Responses to the NuSAG committee from the T2K 2KM group

Figure 1: Sensitivity to $\sin^2 2\theta_{13}$ as a function of exposure for three uncertainties in the background prediction. This figure assumes that the J-PARC accelerator delivers 1.0×10^{21} protons per year of operation from the beginning of the experiment with a 40 GeV beam energy.

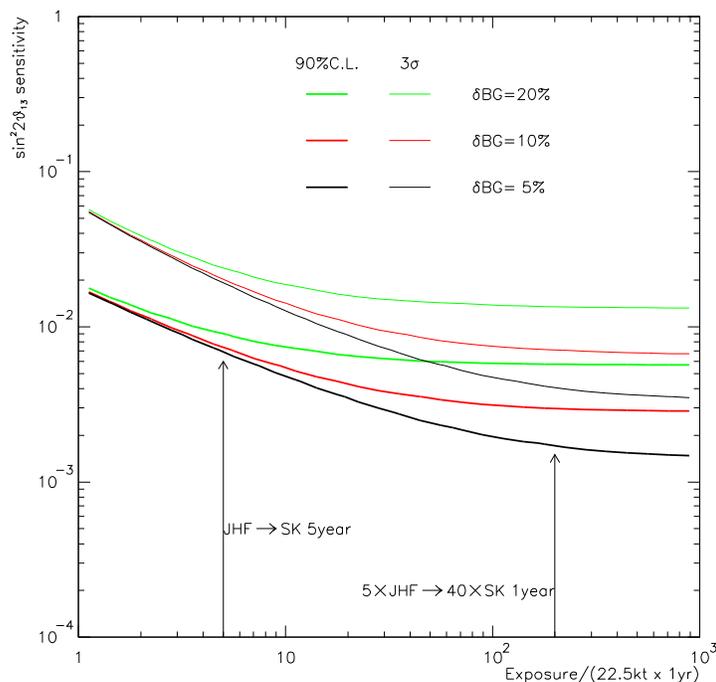
Q2: What is your sensitivity (to ν_e appearance and to $\sin^2(\theta_{13})$) vs. calendar time for 20%, 10%, and 5% systematic errors?

A2: Figure 1 shows the sensitivity as a function of exposure for Super-K with 20%, 10% and 5% uncertainties in the background normalization in the 40GeV JPARC beam. This figure assumes that the J-PARC accelerator delivers 1.0×10^{21} protons per year of operation from the beginning of the experiment with a 40 GeV beam energy and a beam power of 0.67 MW. As can be seen, if the total background uncertainty is allowed to approach 20% the result becomes systematics-limited. Our goal is to control the total uncertainty at about 10% with the ND280 detector alone and below 10% with the ND280 and 2KM detectors combined.

Figure 4: $P(\nu_\mu \rightarrow \nu_e)$ and $P(\bar{\nu}_\mu \rightarrow \bar{\nu}_e)$ are plotted as a function of the CP phase and the mass hierarchy. (Plot from hep-ph/0310023 by Minakata, Nunokawa and Parke.)

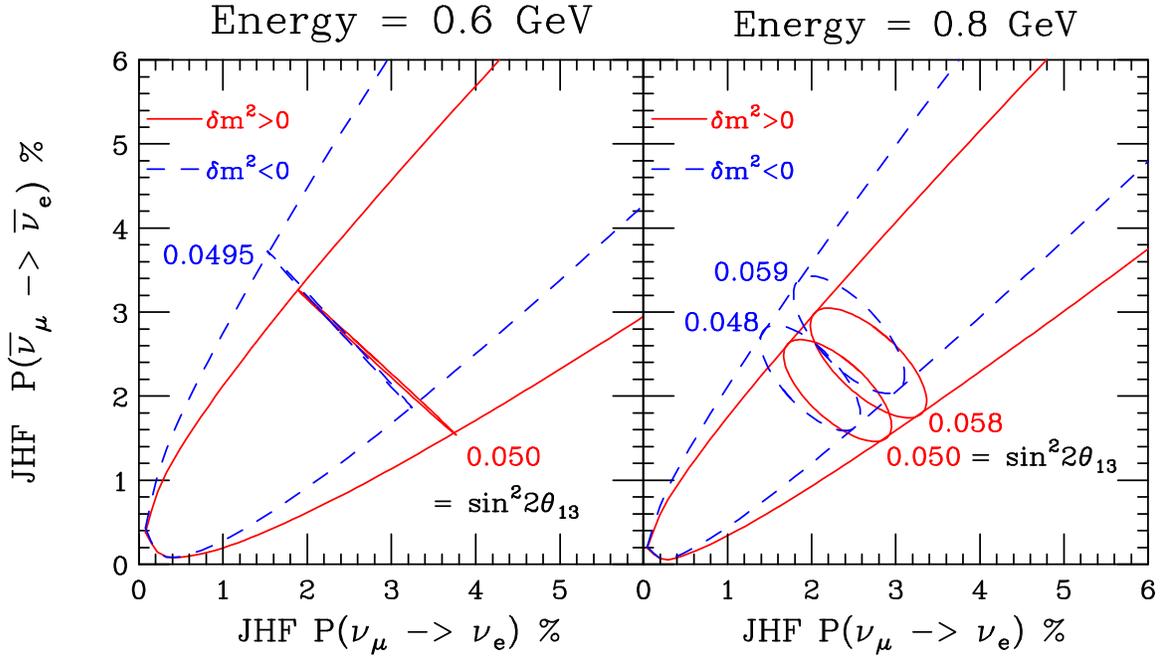
Q3: In the absence of a reactor θ_{13} measurement, how well and unambiguously can you determine θ_{13} and θ_{23} ?

A3: Currently, we are still doing full calculations to answer this question. However, we present our rough estimate. Regarding the θ_{13} determination, if we only run with neutrinos and we know θ_{23} perfectly, we expect that the uncertainty in $\sin^2 2\theta_{13}$ due to uncertainties in δ is approximately a factor of two or more. This can be seen in the following plot taken from hep-ph/0310023 by Minakata, Nunokawa and Parke.

The left hand panel shows the relationship between neutrino and anti-neutrino oscillation as δ is varied between 0 and 2π with a beam whose spectrum has the peak flux at the maximum oscillation energy. The red and blue lines reflect the different hierarchies. The distance between the origin and the collapsed ellipse represents $\sin^2 \theta_{23} \sin^2 2\theta_{13}$. Here we assume that $\sin^2 \theta_{23} = 0.5$. For example, if $P(\nu_\mu \rightarrow \nu_e) = 2.5\%$, $P(\bar{\nu}_\mu \rightarrow \bar{\nu}_e)$ could be between 1% and 5%, and the range of $\sin^2 2\theta_{13}$ could be between 0.035 and 0.075. **In conclusion, the uncertainty in $\sin^2 2\theta_{13}$ is slightly larger than a factor of two even if we know θ_{23} perfectly, at this value of θ_{13} .** Another example may be seen in Figure 5, at the limit of our sensitivity. Here, the limit on $\sin^2 2\theta_{13}$ varies by about a factor of six as delta changes.

after the nominal 5-year period of neutrino running. By combining the ν_e and anti- ν_e appearance data, we expect that the uncertainty due to the CP phase and mass hierarchy can be reduced dramatically since the distance between the origin and the collapsed ellipse in Figure 4 can be determined almost independently of the CP phase and the mass hierarchy.

Figure 5: Sensitivity to $\sin^2 2\theta_{13}$ as a function of δ for different values of the atmospheric Δm^2 .

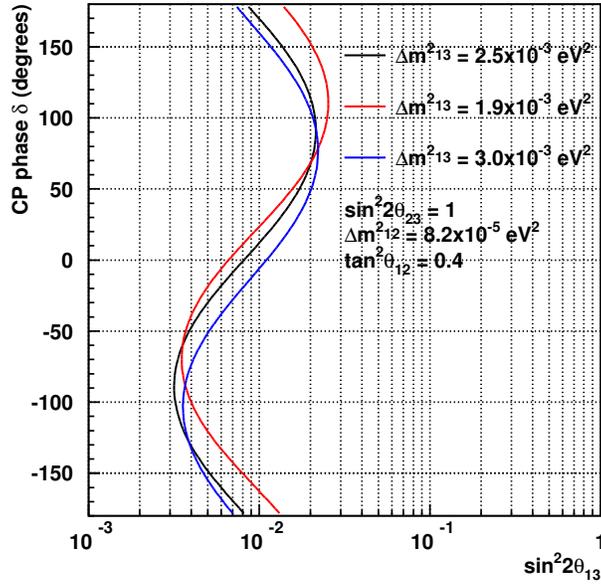
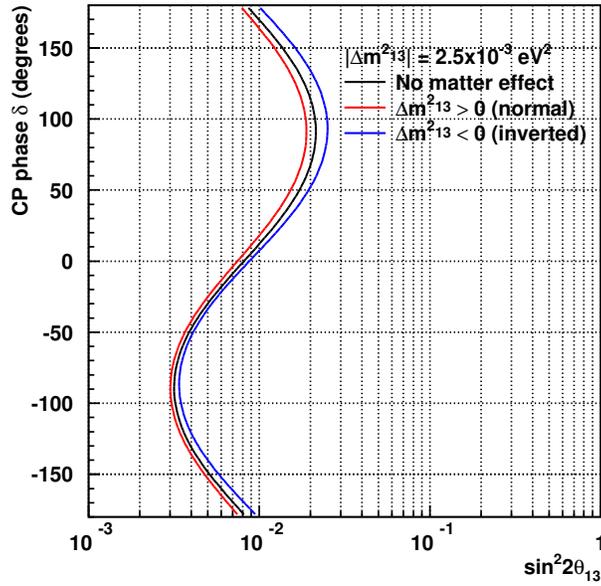
Q4: What is the effect of Δm_{23}^2 on your sensitivity?

A4: **This question is answered best with the following figures: (Figs. 5 and 6).** The first figure shows the 90% C.L. $\sin^2 2\theta_{13}$ sensitivity dependence on Δm_{13}^2 ($\approx \Delta m_{23}^2$), and the second figure shows the dependence on the sign of Δm_{13}^2 .

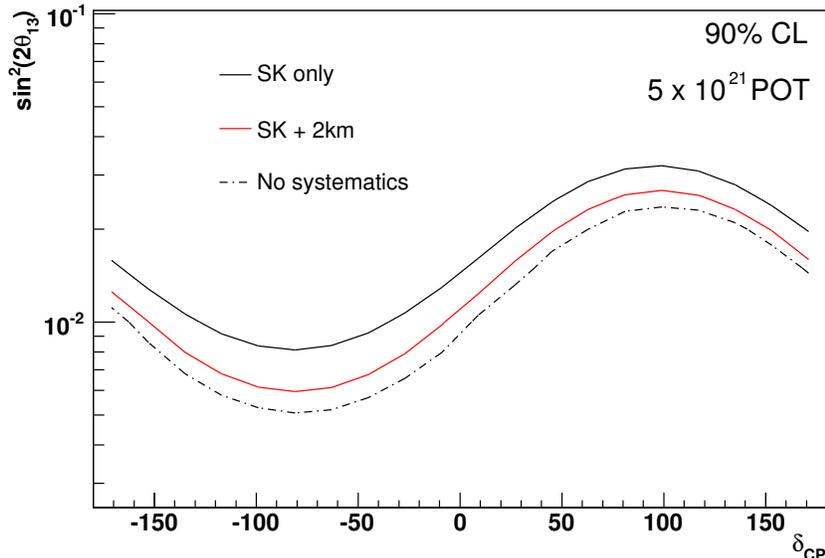
- Q6:** Please discuss as succinctly as possible the added value of the 2 km detector for T2K, given the existence of the 280 m detectors. Comment on the sensitivity to both θ_{13} and θ_{23} , and distinguish between the contributions of the water Cherenkov and liquid argon detectors.
- A6:** There are two types of answer to this question. The first, a quantitative comparison of the θ_{13} sensitivity with and without the 2km detector is difficult at this time since the detailed performance of the 280 meter detector is still under study. **If the 280 meter detector can achieve a 10% total systematic error then the numerical improvement in the sensitivity in the early stages of the experiment due to the addition of the 2km detector will be modest. However, as the luminosity increases our best sensitivity will be achieved with the 2km detector.** Refer to Figure 1.

Regarding the ν_e appearance experiment: Fig. 7 shows that inclusion of the 2KM detector improves the limit on $\sin^2 2\theta_{13}$ by anywhere from a factor of 15% to 30%. If the 280M detector can achieve 10% total uncertainty, we assume the curve using

the 280M detector alone would be somewhat worse than the SK+2KM curve in Figure 7. The use of both together would exceed the SK+2KM limit, approaching, but not reaching, the lowest curve with no systematic uncertainty.

Figure 9: Zoomed view of the simulated raw collection view of a beam-induced neutrino interaction with an overlapping out-of-time crossing cosmic ray muon.

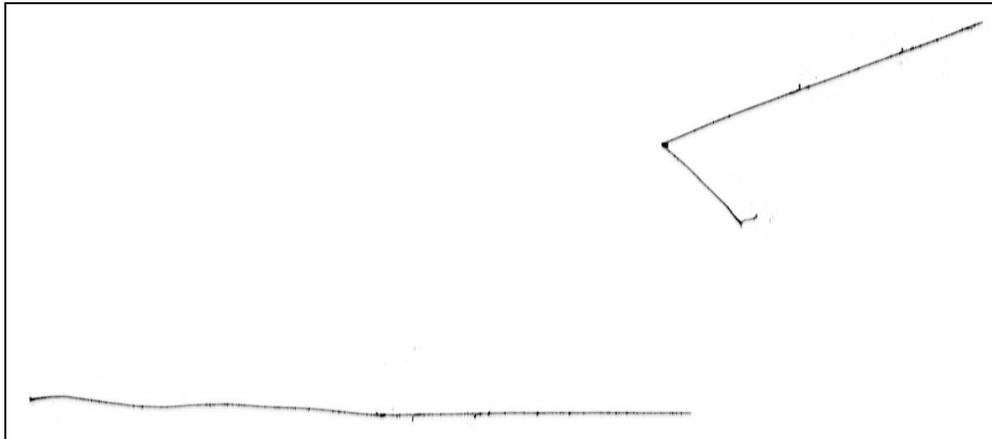
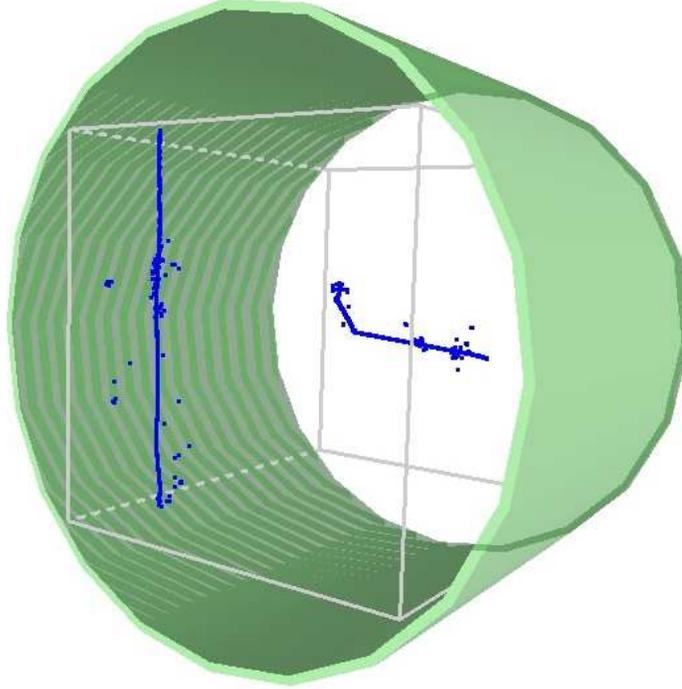
Q10: The maximum drift time in the LAr detector is 1 ms, and the area of LAr tank is roughly 1/2 the area of the Cherenkov water tank, so a simple scaling suggests that the cosmic rate in the LAr detector will be 500 Hz, leading to a dead time of $500\text{Hz} * 1\text{ms} = 50\%$ from cosmic ray triggers. Is this naive estimate correct?

Neutrino interactions taking place while a muon is going through the detector have been simulated. In $\sim 80\%$ of these events the tracks coming from the neutrino interaction and the muon track are well separated in the drift coordinate and the cosmic ray does not affect the reconstruction at all. (Figure 9 and Figure 10). When two 2D views are matched to have a 3D reconstruction the major complication comes from hits on different wires at the same time; since both the direction of the neutrino beam and the main direction of cosmic rays are orthogonal to the drift direction, it is possible to have a good 3D reconstruction most of the time.

and the result is that 1.1% of the generated muons enter the LAr active volume and 1.1% enter only the non-active LAr volume. The number of muons that enter the shaft in 1 ms is ~ 11 which means that the average number of muons crossing the LAr detector in 1 ms is ~ 0.1 . **Our conclusion is that less than 2% of the events will be affected in the analysis because of overlapping cosmic rays.**
